Fort Peck Fisheries - Shop Building
Fort Peck, Montana **September 22, 2014**

END OF ADDENDUM #1

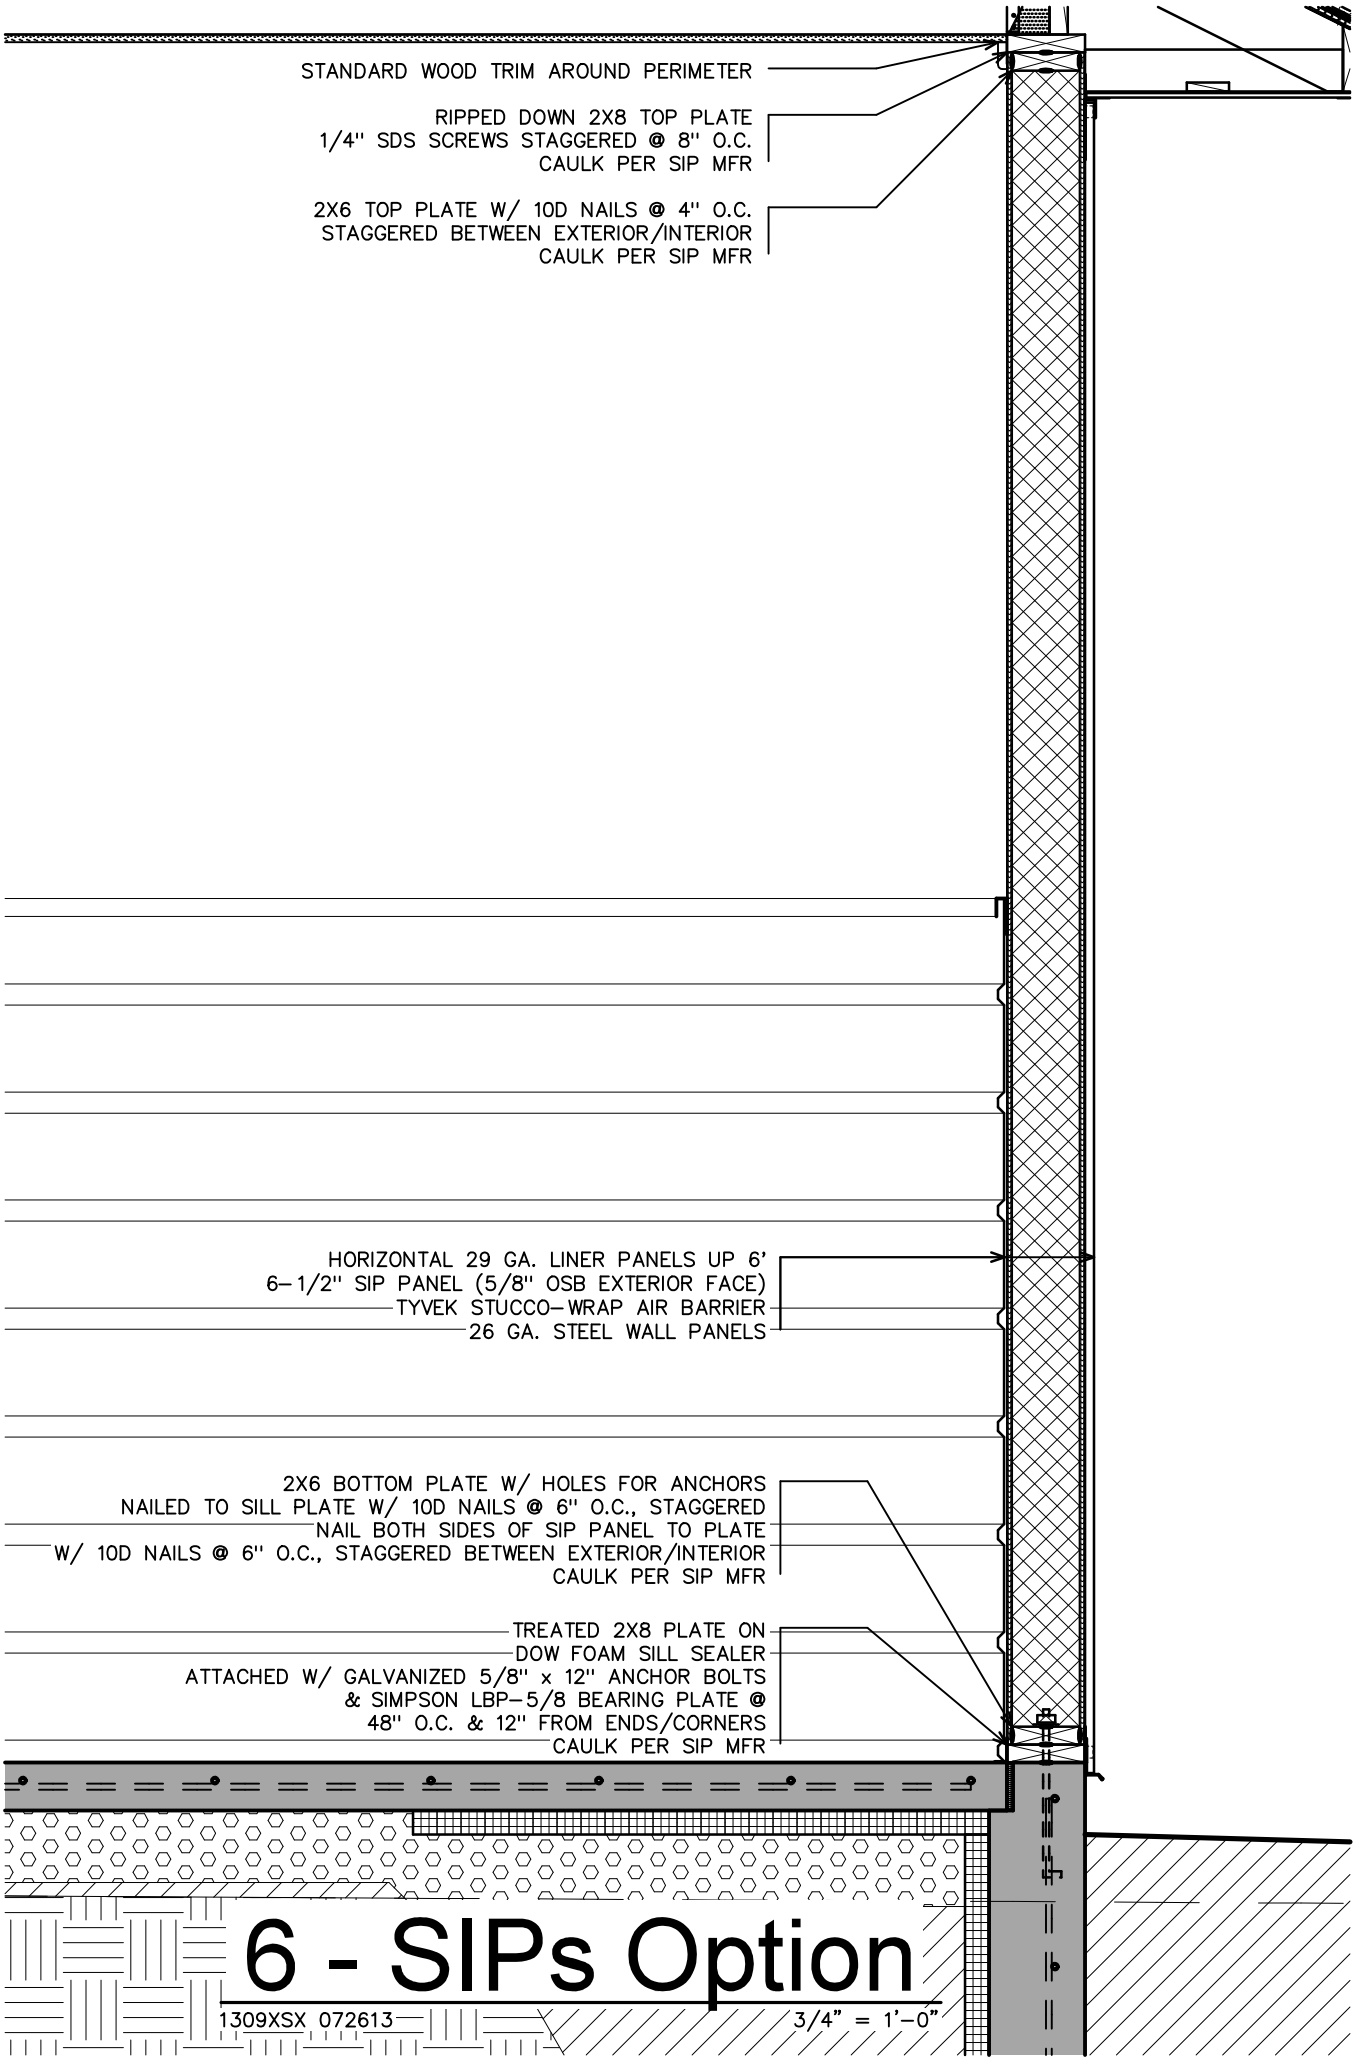
A. **Contractor's Option** to use SIPs in lieu of wood framed exterior walls per attached specification (§06 12 00 Structural Panels) and typical wall drawing. Contractor will be responsible for any other changes that may result from their choice to use SIPs.

OSB - shall be identified on the panel with an APA or TECO performance rating mark with an Exposure 1 durability rating; minimum physical properties shall be tested and meet PS 2. **Exterior face to be 5/8" thick, minimum.**
